Office Action Summary

10/690,147

CANONICO, STEPHEN H.

DETAILED ACTION

Figure 1: Korsmo US 2,800,798

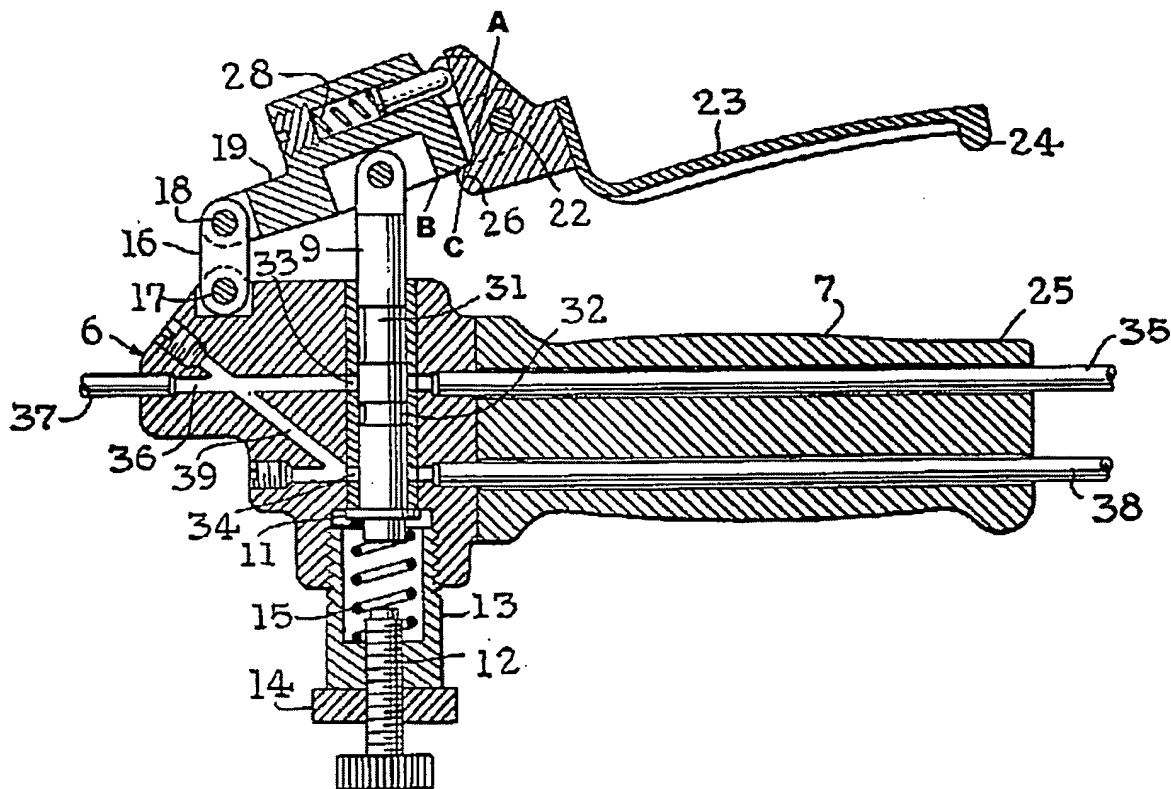
Claim 1 is rejected under 35 U.S.C. 102(b) as being anticipated by Korsmo US 2,800,798.

Korsmo shows in Figure 1 below, a lever body (23) mounted for pivoting movement about an axis from a released position, to an actuated position; said lever body having a rearward first fulcrum surface (A) and a rearwardly-extending lip (26) proximate said first fulcrum surface; a lever arm (19) having a forward edge portion (B) and a second fulcrum surface proximate said forward edge portion (C), said first fulcrum surface and said second fulcrum surface being adapted for mating engagement when said forward edge portion is engaged under said lip; and tensioning means (28) for applying a contraction force between said first fulcrum surface and said second fulcrum surface that biases said first and second fulcrum surfaces into mating engagement.

Figure 2: Brainard US 6,516,682

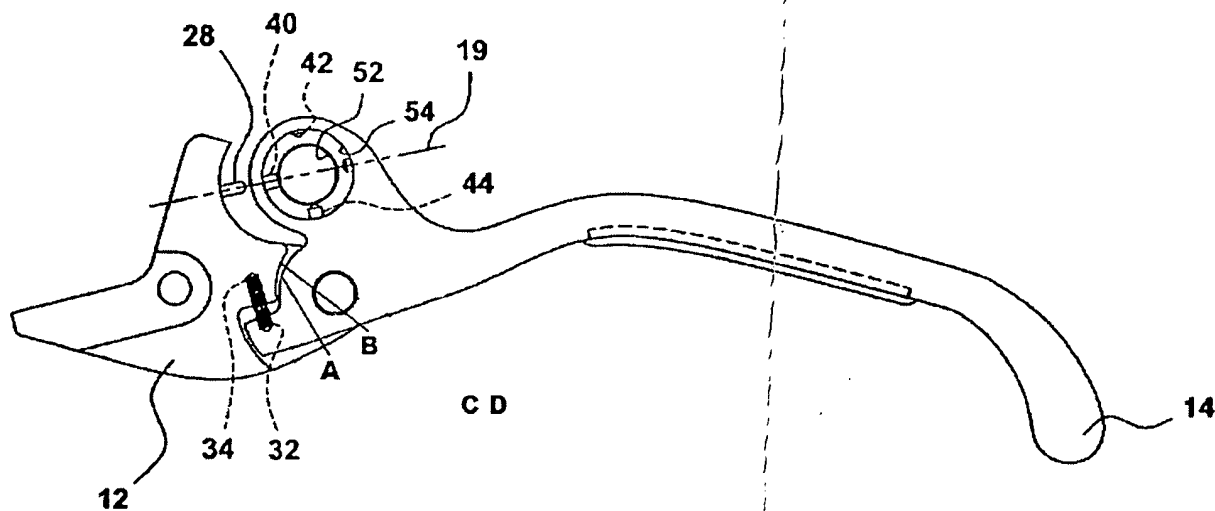
Claims 2 and 3 are rejected under 35 U.S.C. 103(a) as being unpatentable over Korsmo US 2,800,798 in view of Brainard US 6,516,682.

Korsmo discloses a hand operated jointed control lever as described in the rejection of claim 1 above, including a first and second fulcrum surfaces, but does not disclose the surfaces being arcuate or cylindrically concave and convex.

Brainard shows in Figure 2 below, a hand operated jointed control lever with first and second mating surfaces (A, B) that are cylindrically concave and convex.

It would have been obvious to a person of ordinary skill in the art at the time the invention was made to modify the lever assembly disclosed by Korsmo such that the mating surfaces be cylindrically concave and convex in view of Brainard to provide a larger contact area therefore allowing for a better distribution of force and lessening the stress on the mating components.

Figure 3: Sogoian US 3,940,165

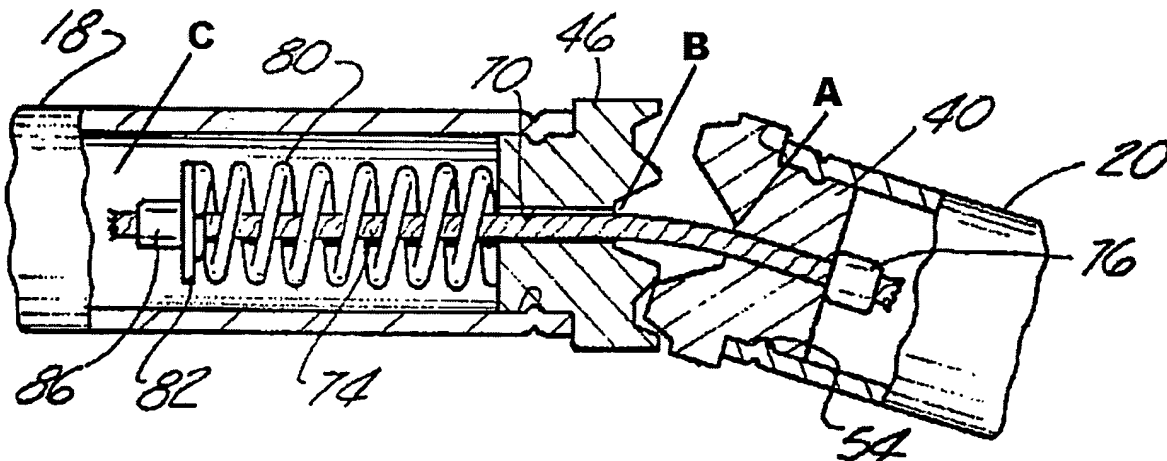
6. Claims 4 and 5 are rejected under 35 U.S.C. 103(a) as being unpatentable over Korsmo in view of Sogoian US 3,940,165.

Sogoian shows in Figure 3 below a tensioning cable (74) passing through the first (A) and second (B) fulcrum surface, said tensioning cable having a first end (76) and a second end (86), said first end being secured to said lever arm (20); and a compression coil spring (80) interposed between the second end of the tensioning cable and the lever body within a cavity (C) formed within said lever body (18), and the tensioning cable passing axially through the coil spring.

It would have been obvious to a person of ordinary skill in the art at the time the invention was made to modify Korsmo such that the tensioning means comprises a cable passing through a coil spring in view of Sogoian to allow for a greater range of motion when the lever body is angularly deflected relative to the lever arm (Sogoian, ABSTRACT, lines 5-6).
